DEVELOPMENT REVIEW BOARD - **HYDROLOGY SECTION**

DRB Project Number: 2022-006500 Hearing Date: **01-26-2022**

Project: **LOT 17-A & TRACT A BLOCK 7 UNIT 5, VOLCANO CLIFFS** zoned **R-1D** Agenda Item No: **10**

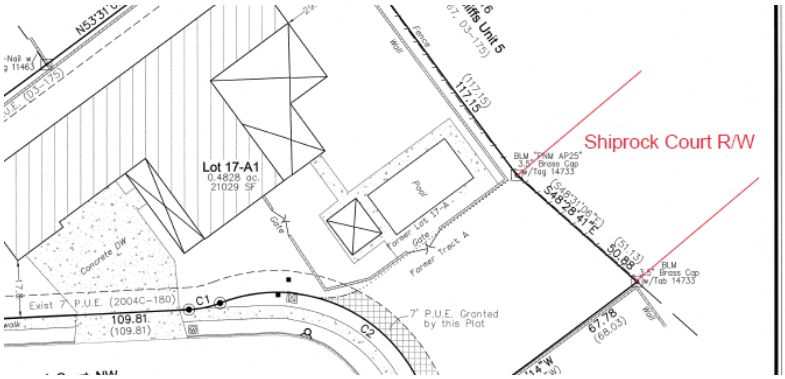
- Please show existing Shiprock Court Right of way adjacent to Lot 16 shown on the plat.
